**SUBSURFACE WASTEWATER DISPOSAL SYSTEM APPLICATION** Department of Human Services  
Division of Health Engineering  
(207) 287-5672 FAX (207) 287-4172

City, Town or Location: AUGUSTA

# REPLACEMENT SYSTEM VARIANCE REQUEST

Subject: Approval, Replacement System Variance Request, Poulin property, Route 105, Augusta

**SITE PLAN** Scale **1" = 50'** Ft.  
or as shown

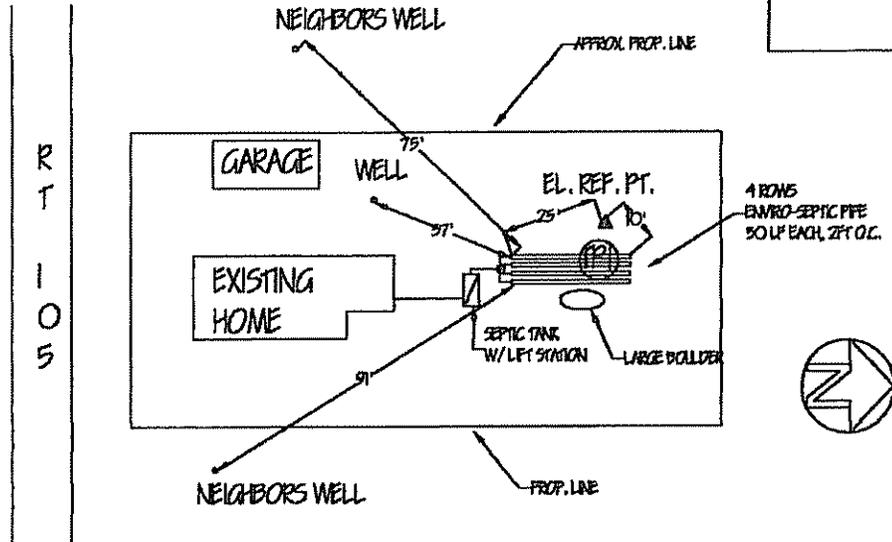
The Division has reviewed a Replacement System Variance Request for the subject property. The state variances requested are to allow the installation of a subsurface wastewater disposal system with setback reductions of 37 feet (disposal field), 37 feet (septic tank) to the property owner's well and a reduction in the fill extension grade to 3:1 where necessary. The system design prepared by Paul Beers, SE, dated 5-15-00, is slated to be installed six inches above the old fill material. The property owner's well is stated to be a non-potable water supply. The design is found to be in compliance with the Maine Subsurface Wastewater Disposal Rules.

We approve the requested variances with the following requirements:

1. A permit for system installation is to be obtained from the Local Plumbing Inspector in advance of the start of system construction.
2. The system is to be installed in accordance with the submitted and approved system design. Should alterations be required at the time of system installation, the system designer must be notified prior to making any changes.
3. The property owner's well is to remain a non-potable water supply. Any drinking water supply well placed on the property must be at least 100 feet from the septic system or comply with the well setback reduction criteria.
4. The variance approval is based only on the rules administered by this department. The approval of the variance request does not relieve the property owner from compliance with all other state and local requirements pertaining to the installation, use, and operation of the wastewater disposal system.

## SUBSURFACE WASTEWATER DISPOSAL PLAN

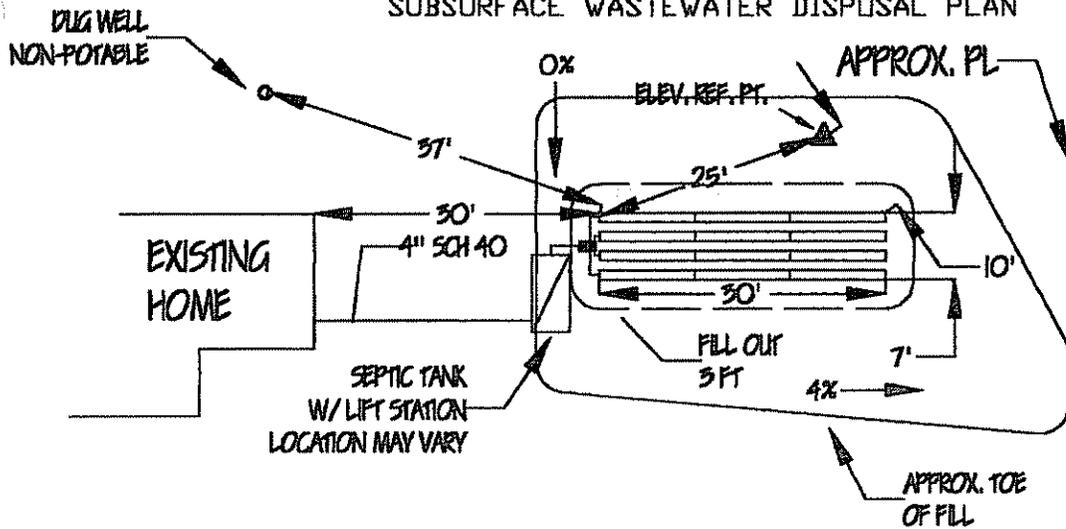
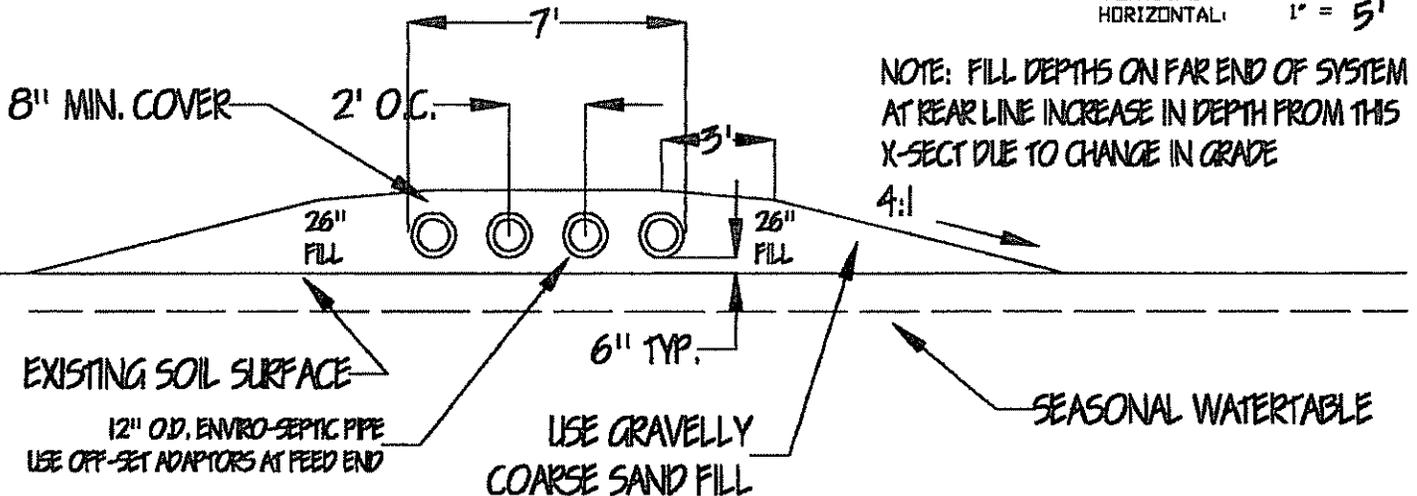
NOTE: THE PROPOSED SYSTEM IS LESS THAN 100' FROM ABUTTORS WELL, BUT IS NO CLOSER THAN EXISTING SYSTEM; SEE PAGE 2 FOR LOCATIONS
